EAGLE RIDGE

Final Environmental Impact Statement

Town of North Castle – Town Board

December, 2020

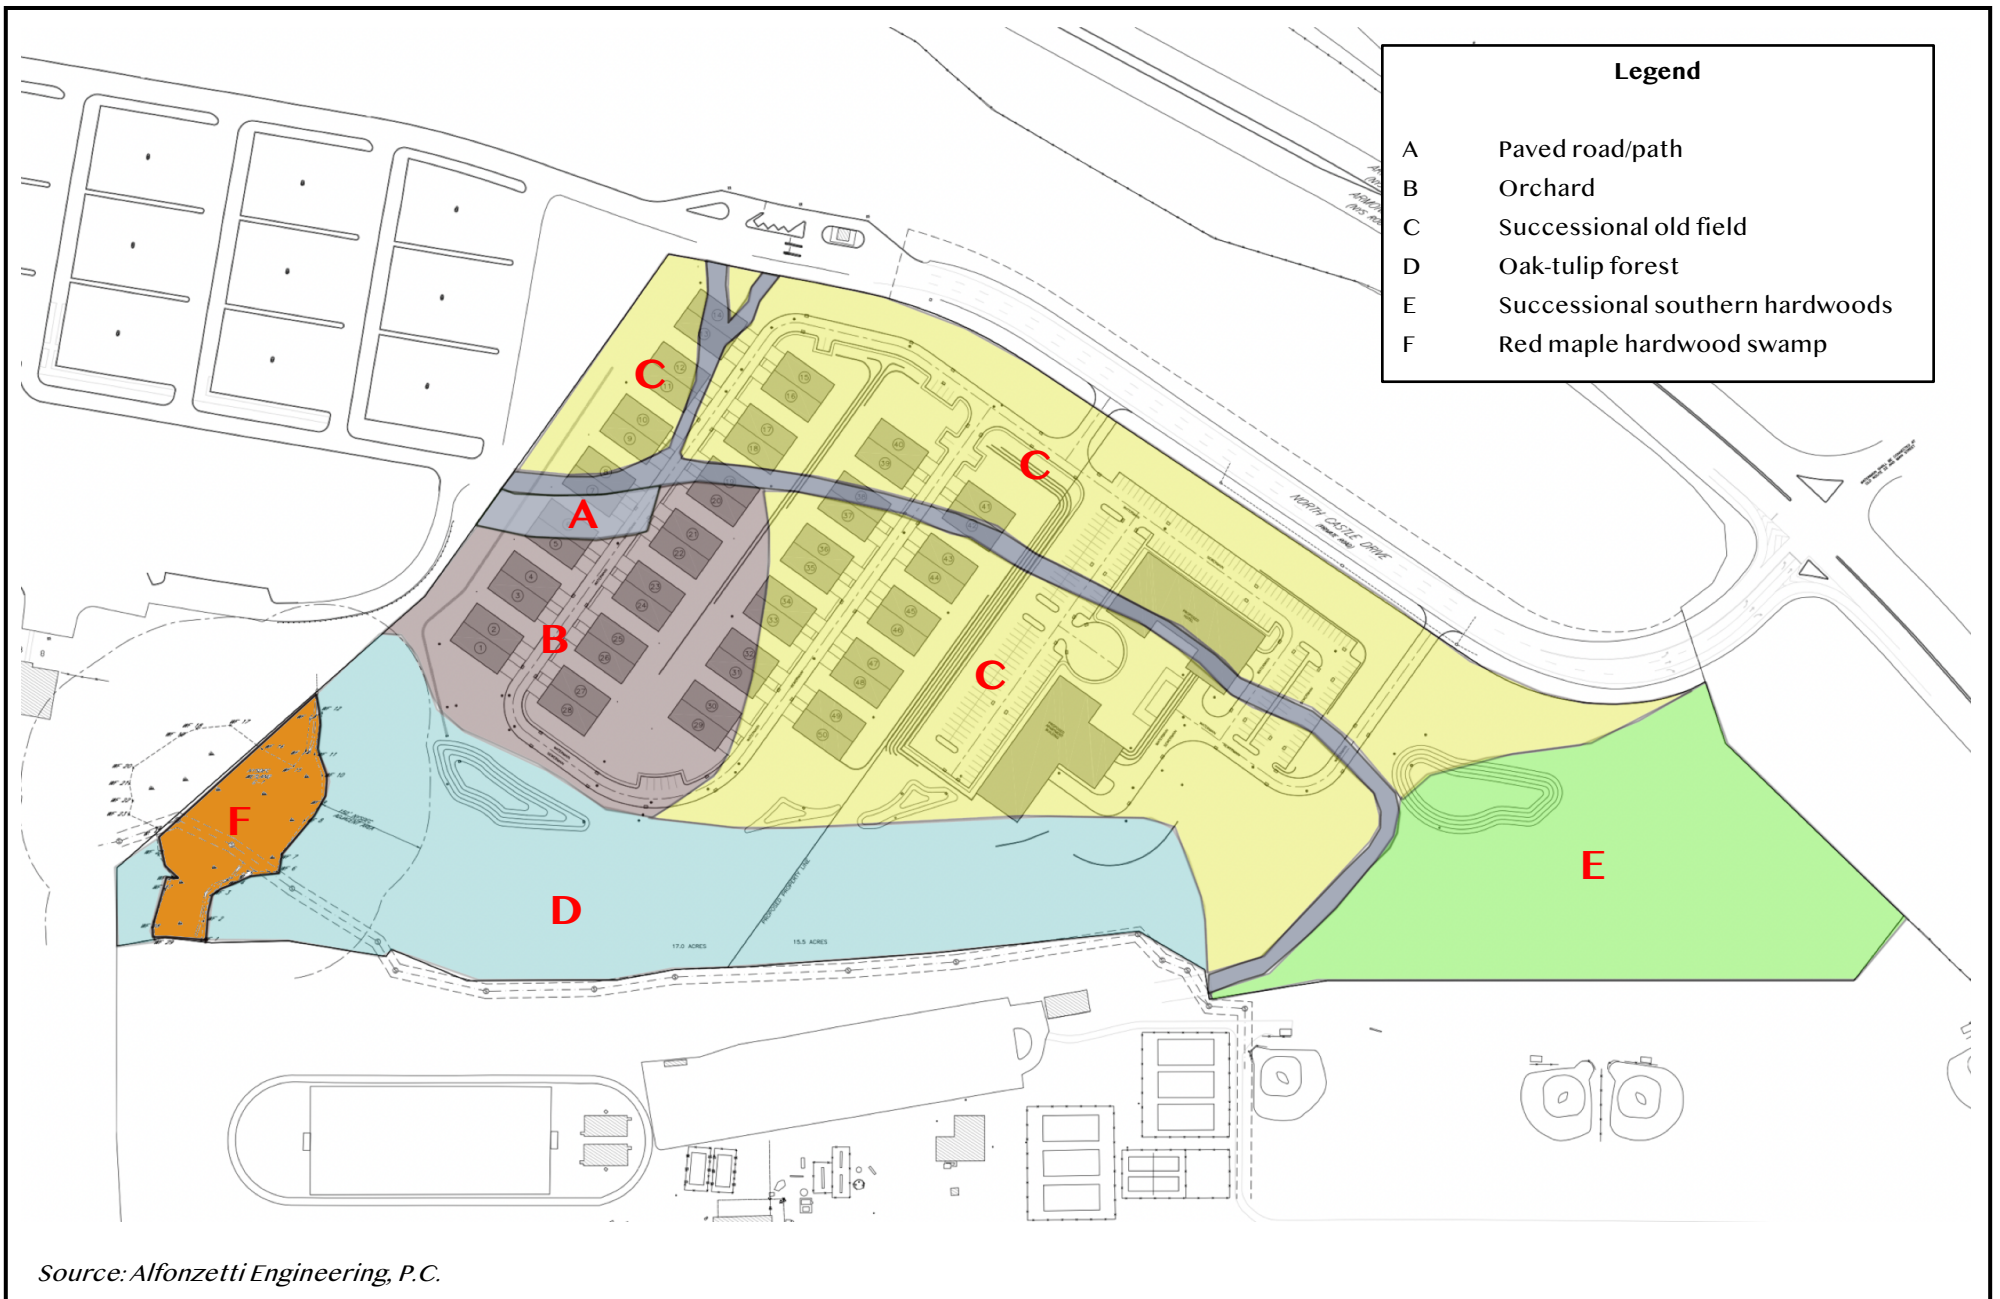
D-3 Comment:

Ecological Communities. An additional exhibit after Figure IV.D-2 that depicts the Site Ecological Communities overlaid with the Proposed Action would be helpful to better understand proposed impacts to site ecological communities. (Town of North Castle Planning Department - July 8, 2019)

D-3 Response:

Refer to Figure III.D-1 – FEIS Plan/Ecological Community Overlay Map.
